## ADDENDUM NO. 2

Date: April 23, 2015

Project Name: Alberta Revitalization Infrastructure Project Phase 1B  
for the City of Tuscaloosa

City Project Number: A12-1324  
WA Project Number: 12-100

Sheet No.	<b>E2.0</b>
-----------	-------------

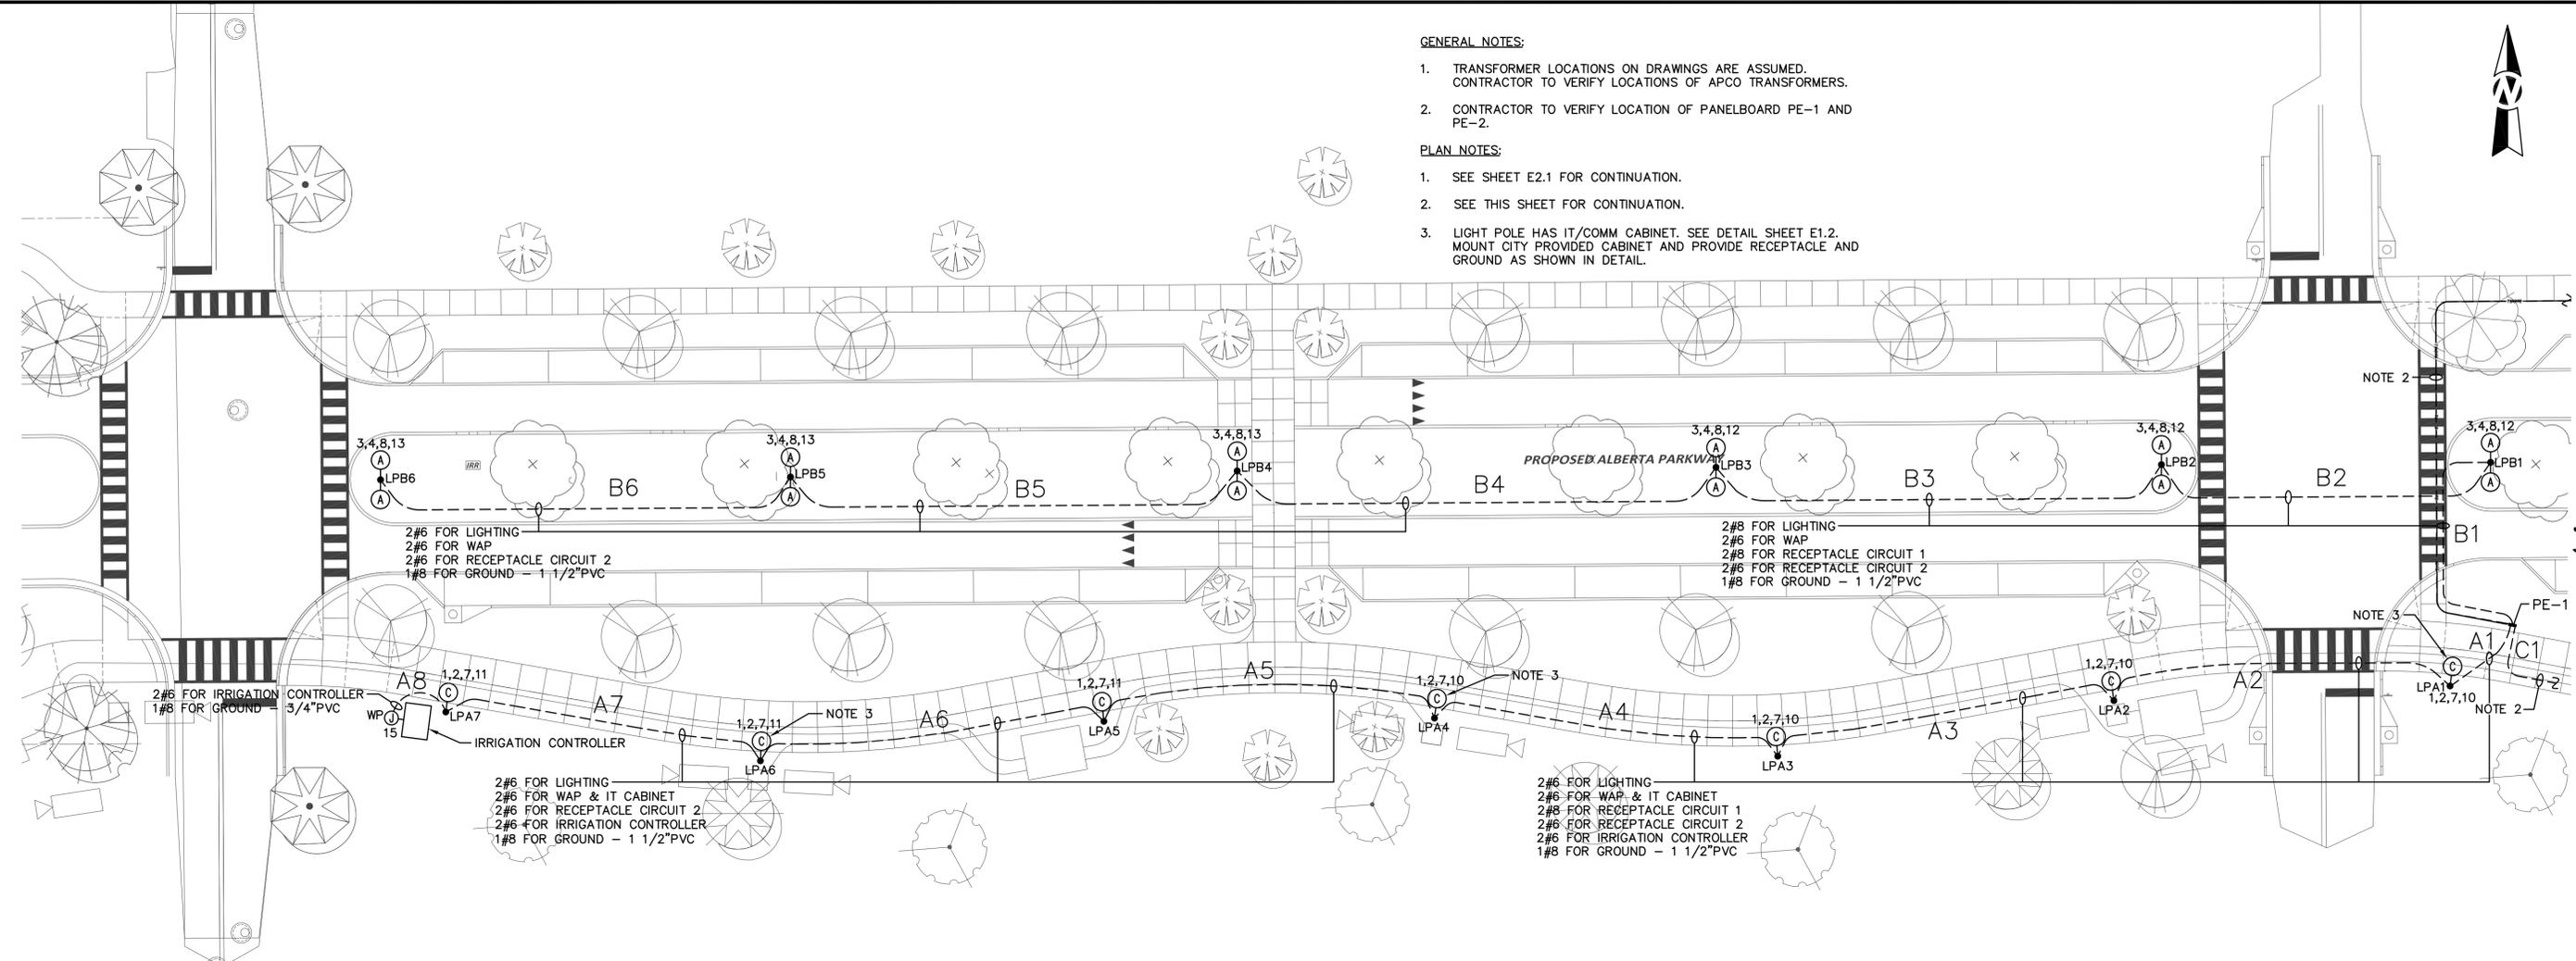
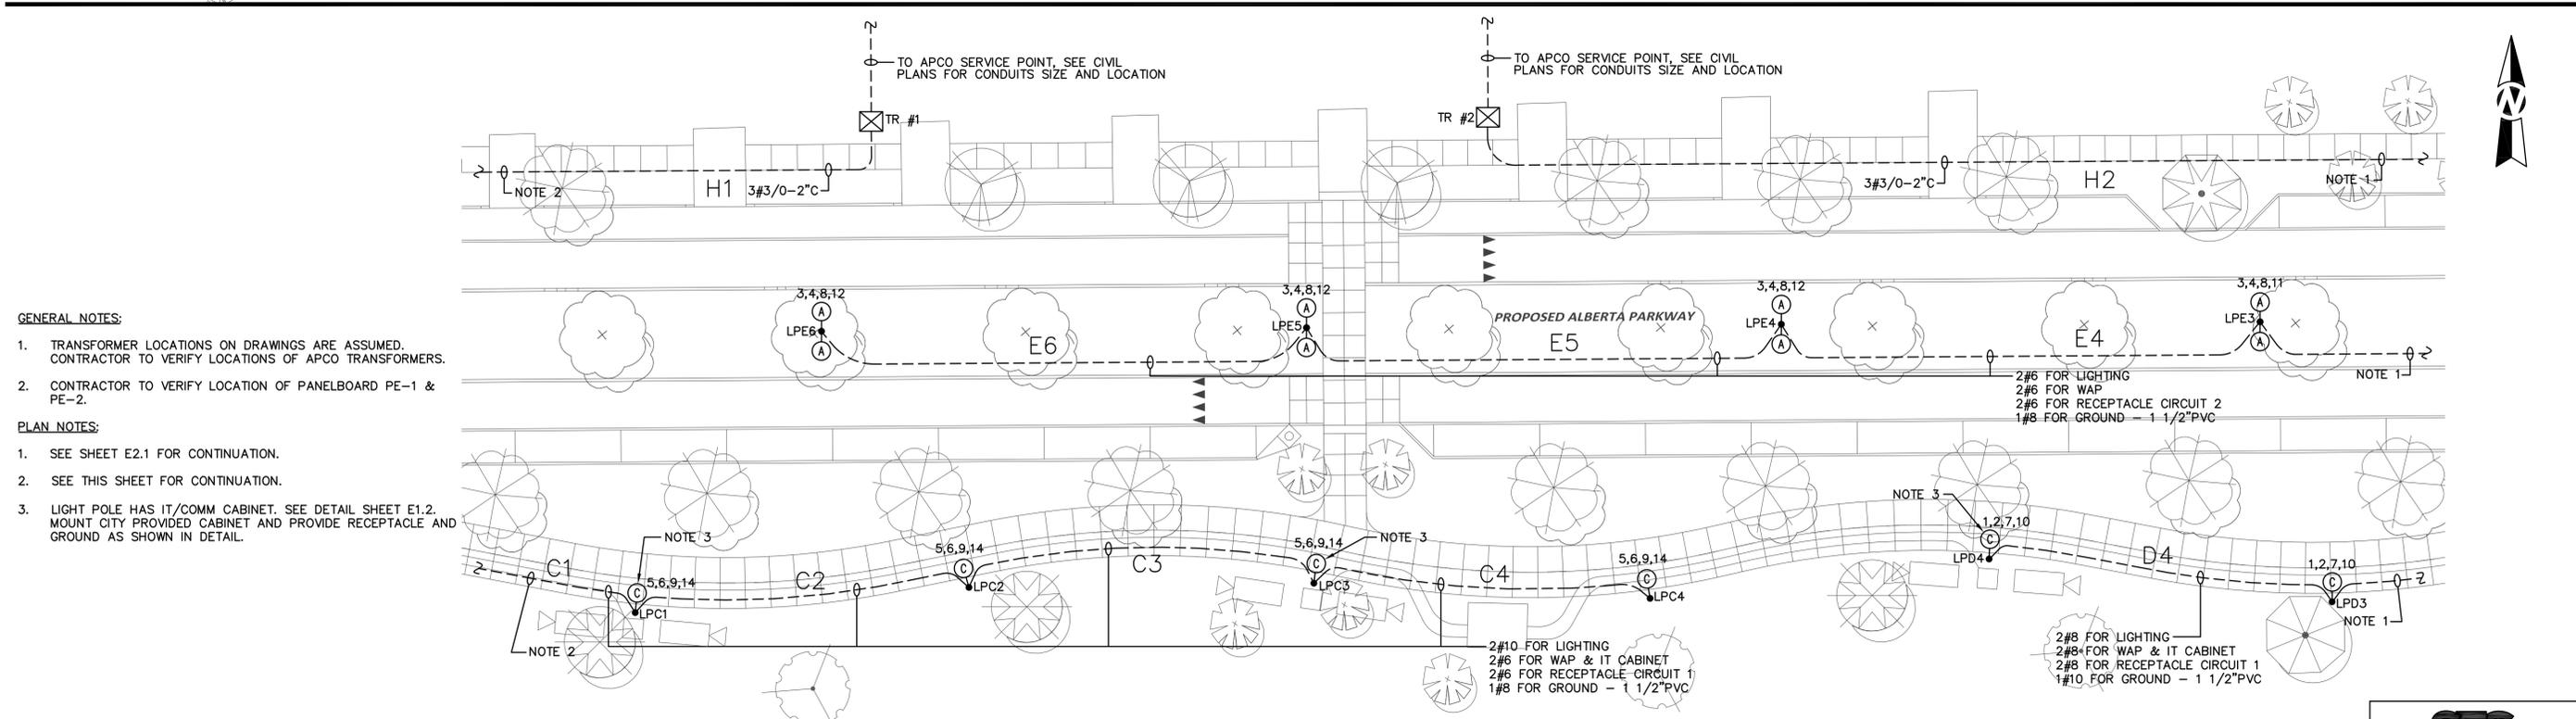
The following plans sheets have been revised to provide clarification to the above questions and shall replace the original plan sheets found in the contract documents in their entirety. Also, a light pole schedule has been added to clarify the pole types and whether the various poles include cameras and WAP's.

1. SEE SHEET E2.1 FOR CONTINUATION.
2. SEE THIS SHEET FOR CONTINUATION.
3. LIGHT POLE HAS IT/COMM CABINET. SEE DETAIL SHEET E1.2. MOUNT CITY PROVIDED CABINET AND PROVIDE RECEPTACLE AND GROUND AS SHOWN IN DETAIL.
